Service Bulletin

SEPTEMBER 1957 NO. 328

Studebaker and Packard Clipper

Fig. 2

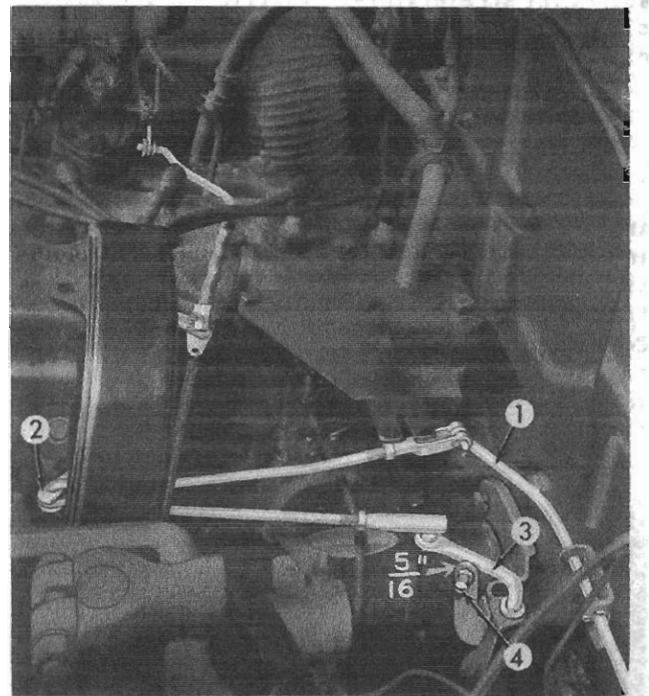
Set the selector lever in the P or N position and operate the engine until it reaches operating temperature and the carburetor choke is in the wide open position. Disconnect the rod which connects the accelerator bracket (1, Fig. 2) to the auxiliary bellcrank (2) by removing the clevis pin from the clevis.

Disconnect the rod which connects the main bellcrank (3) to the auxiliary bellcrank (2) by removing the ball joint stud from the main bellcrank lever. Adjust the screw (4) to provide a 5/16" (7.94mm.) gap between the bellcrank and the pad. A 5/16" drill should be used as a gauge.

Adjust the ball joint on the main bellcrank-to-auxiliary bellcrank rod until the ball joint stud freely enters the hole in the main bellcrank lever. During this adjustment the carburetor idle speed screw must be against its stop and the 5/16" gap at the bellcrank must be maintained.

Place the selector in the D position and operate the engine at 1000 r.p.m. with the rear wheels held stationary by the foot brake. Adjust the length of the main bellcrank-to-throttle valve outer lever rod to obtain 80-85 p.s.i. Stop the engine and remove the pressure gauge and install the 1/8" pipe plug.

Hold the accelerator bracket arm approximately 3 7/8" (9.82cm.) from the fire wall and,

adjust the accelerator-to-auxiliary bellcrank rod clevis until the clevis pin freely enters the clevis and the bracket arm.

Fig. 3

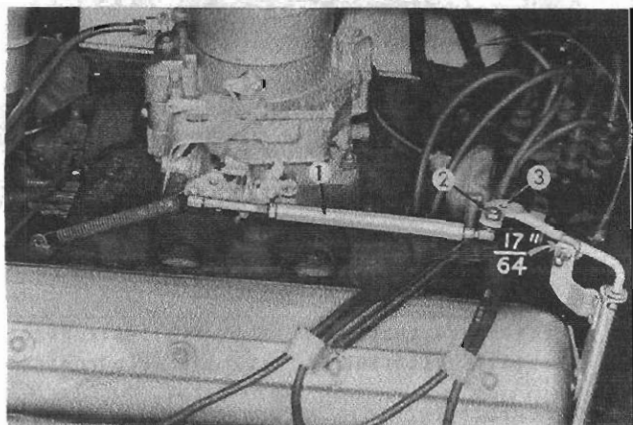
Set the stop on the bellcrank to provide $17/64$ " (6.747mm.) gap between the bellcrank pads (see Fig. 3). A $17/64$ " drill should be used as a gauge. After the stop has been adjusted, hold in this position. Make sure that the carburetor to-bellcrank rod ball joint is in the inner hole of the bellcrank pad (toward the center line of the engine) and that the ball joint is on the underneath side of the bellcrank. NOTE: The carburetor-to-bellcrank rod ball joint should be in the outer hole of the bellcrank pad (away from the centerline of the engine) and the ball joint should be on the upper side of the bellcrank on cars equipped with a supercharger. Adjust the carburetor to bellcrank rod until the idle speed adjusting screw just begins to leave the stop.

Adjust the length of the bellcrank-to-throttle valve outer lever rod to obtain 80-85 p.s.i. (95-100 p.s.i. on cars equipped with supercharger or heavyduty transmissions such as used on police cars, etc.). Stop the engine and remove the pressure gauge and install the $1/8$ " pipe plug.

Set the stop on the bellcrank to provide $17/64$ " (6.747mm.) gap between the bellcrank pads (see Fig. 3). A $17/64$ " drill should be used as a gauge. Make sure that the carburetor-to-bellcrank rod ball joint is in the outer hole (away from the centerline of the engine) and that the ball joint is on the underneath side of the bellcrank lever. Adjust the carburetor-to-bellcrank rod until the idle speed adjusting screw just begins to leave its stop.
